UNITED STATES
NUCLEAR REGULATORY COMMISSION
WASHINGTON, D. C. 20555

DOCKET NO.: 40-8027
APPLICANT: Kerr-McGee Nuclear Corporation (KM)
FACILITY: Sequoyah Uranium Hexafluoride Production Plant
SUBJECT: SAFETY EVALUATION REPORT -
LICENSE AMENDMENT APPLICATION FOR AUTHORIZATION
TO REDUCE THE SAMPLING FREQUENCY OF THE 26
ENVIRONMENTAL MONITORING LOCATIONS
LICENSE NUMBER: SUB-1010
AMENDMENT NO.: 5
REVIEWER: A. L. Soong

Fig. 1. Raffinate Ponds and Monitoring Stations

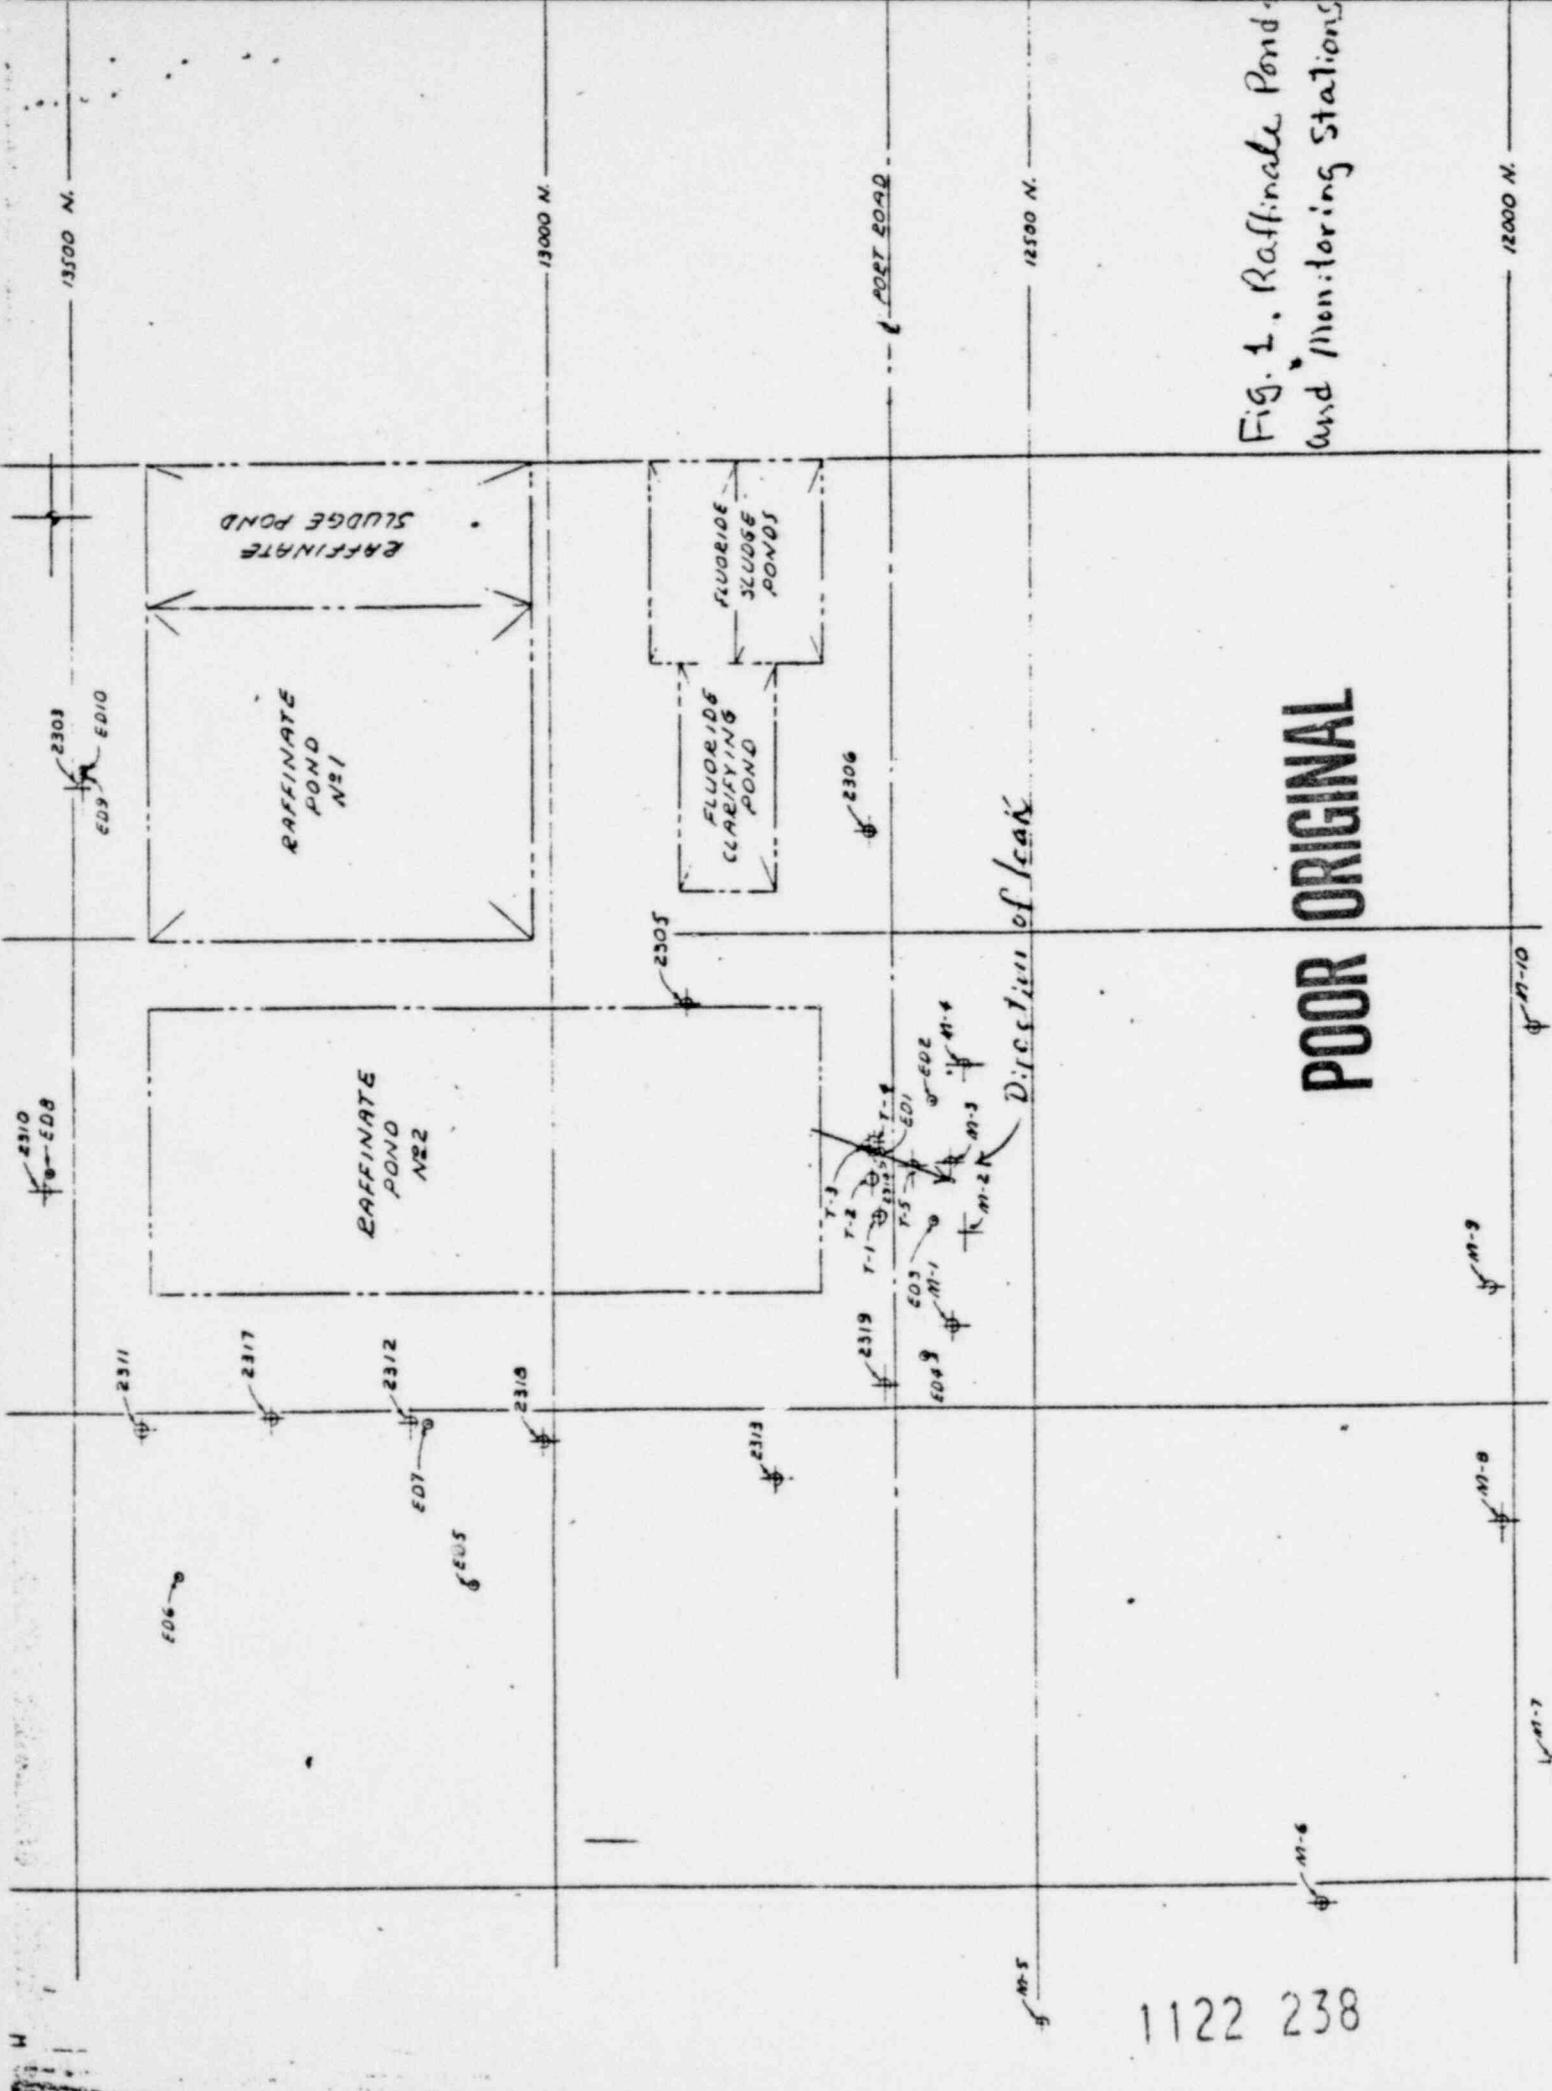
The M series groundwater monitoring wells (see Table 1 and Figure 1) were installed in 1974 among others for monitoring the leak from raffinate storage pond #2. Since their installation, all monthly collected samples (except M-3 well which is not included in the application) have shown an insignificant level both in radiological and non-radiological contaminants. The result of the extensive studies regarding the leak of pond #2, however, may be summarized as follows (see KM's letter to NRC dated February 3, 1979, annual report concerning leakage of pond #2):

- (a) The leak is confined to a relatively narrow band and extends to about 80 feet south of the pond.
- (b) The leakage rate from pond #2 is estimated at about one gallon per day which flows to the south. The leakage rate has remained essentially unchanged since 1976.

Based on the above conclusions, the staff considers that KM's request for quarterly sampling from the M series wells is adequate. Furthermore, in order to ensure an earlier warning of further spreading from the leakage, the staff proposed to the licensee that should an elevated nitrate level be detected in the M-6 to M-10 wells which are located about 800 feet south of the pond, KM shall investigate the possible cause of this nitrate elevation in the sample and report to the NRC.

1. If any groundwater sample from well M-5, M-6, M-7, M-8, M-9, or M-10 shows concentration in excess of 10 mg/liter of nitrate (as N), the licensee shall investigate the cause of the elevated analytical result and promptly report to the NRC Inspection and Enforcement Region IV Office.
